NOTICE OF APPROVAL

Planning Case #: Design Study 24078

Project Location: SW Corner of San Carlos & 2nd

Project Description: This approval of Design Study application DS 24078 (Ramos-Oreo) authorizes replacement of exterior doors and windows, in-kind replacement of wood siding, resurfacing the upper rear deck with Trex to mimic wood, and a new wood-and-cable railing at the upper rear deck, located at the southeast corner of San Carlos Street and 2nd Avenue in the Single-Family Residential (R-1) zoning district, as depicted on plans dated June 18, 2024, unless modified by the conditions of approval

Permit #: DS 24-078 (Ramos-Oreo)

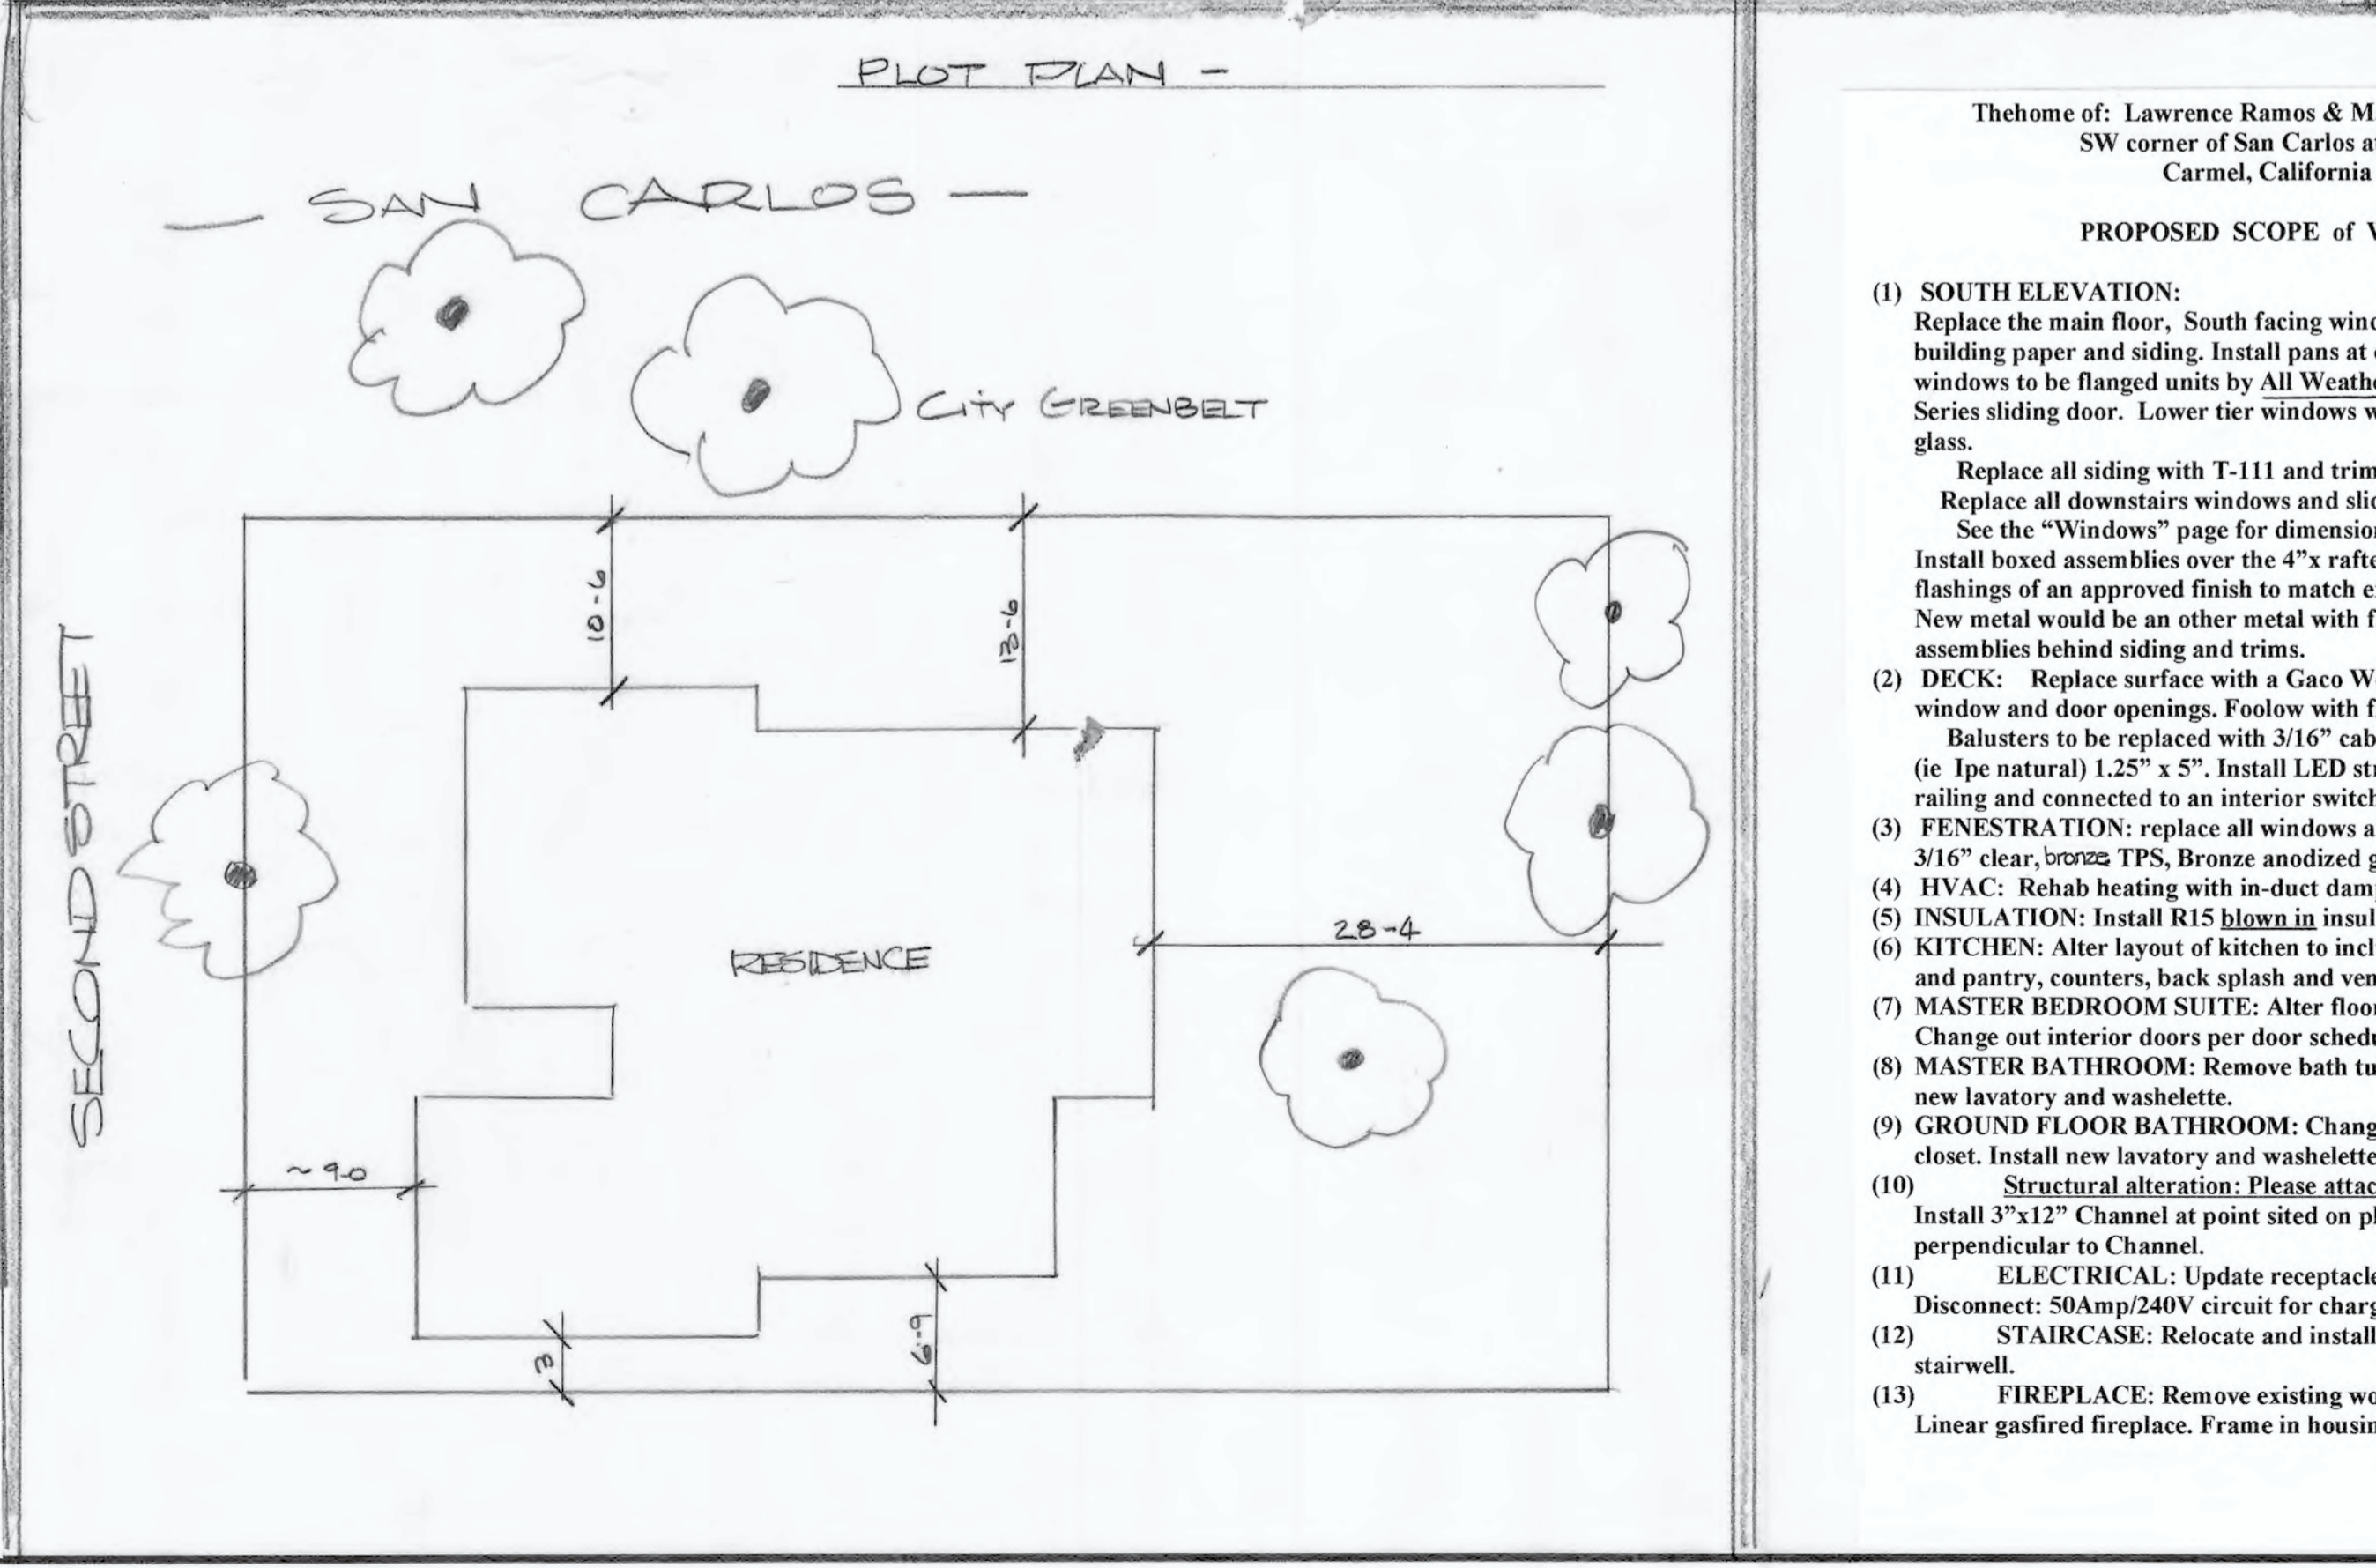
18.	Deck Flooring Material. Prior to issuance of a building permit, the Applicant shall revise the plans to replace the membrane flooring proposed for the deck with a natural material, such as wood or stone, or a product approved by the project Planner that closely mimics the appearance of a natural material.

19.	Deck Lighting. Prior to issuance of a building permit, the Applicant shall revise the plans to replace the LED strip lighting as proposed for the deck with exterior light fixtures that comply with the City municipal code and residential design guidelines (see Standard Condition #9).
